Turkey Point Units 3 and 4

LICENSE AMENDMENT REQUEST FOR EXTENDED POWER UPRATE

ATTACHMENT 3

Technical Specifications Bases Markups
for Information Only

3/4.2.5 DNB Parameters

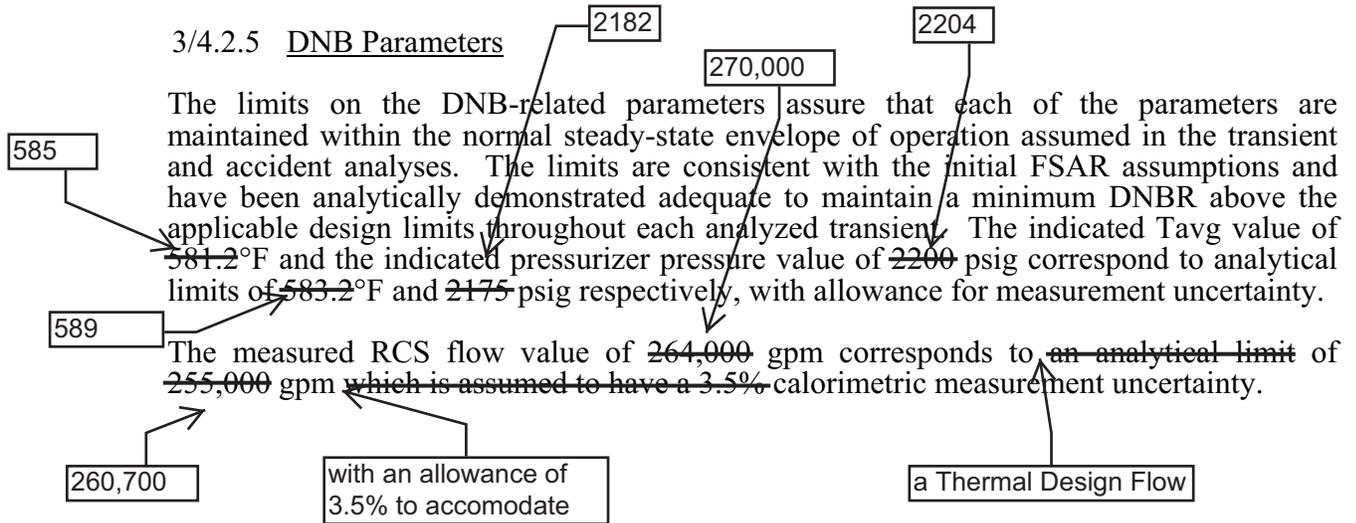
The measured RCS flow value of ~~264,000~~^{260,700} gpm corresponds to ~~an analytical limit of 255,000 gpm which is assumed to have a 3.5% calorimetric measurement uncertainty.~~ ^{with an allowance of 3.5% to accommodate} a Thermal Design Flow
